Appl. No. 10/029,669
Amdt dated August 9, 2004
Reply to Office Action of May 7, 2004

Amendments to the Drawings

FIGURE 1

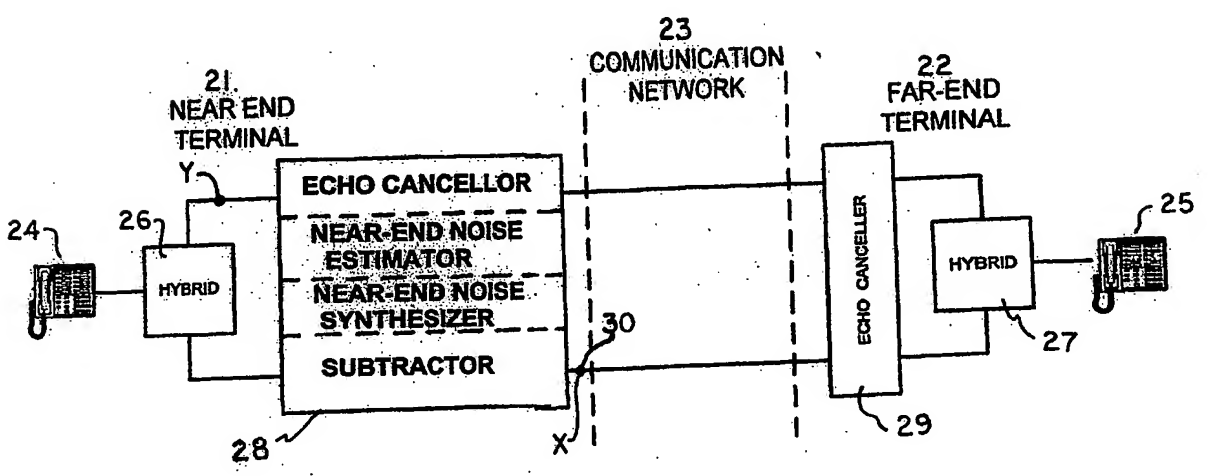
Attached to this Amendment is a Replacement Sheet for Figs. 1 and 2. Fig. 1 schematically illustrates a measuring unit and comparator, which are recited in claim 20, while Fig. 2 schematically illustrates a near-end noise estimator, a near-end noise synthesizer, and a subtractor, which are functionally recited in claim 6.

FIGURE 6

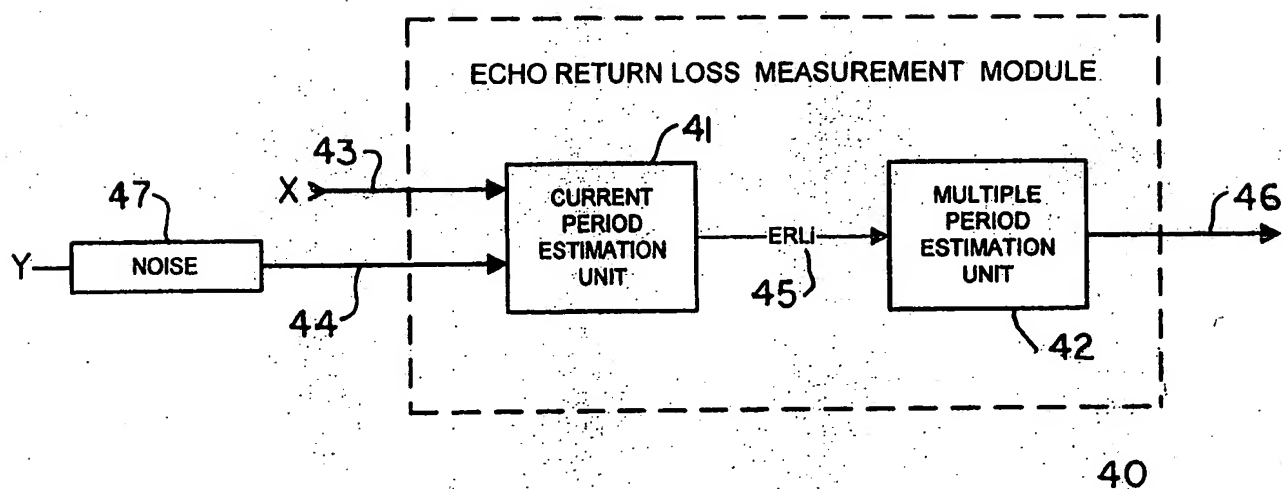
Also attached to this amendment is a Replacement Sheet for Fig. 6, which labels ERL Change Suspected State as 92.
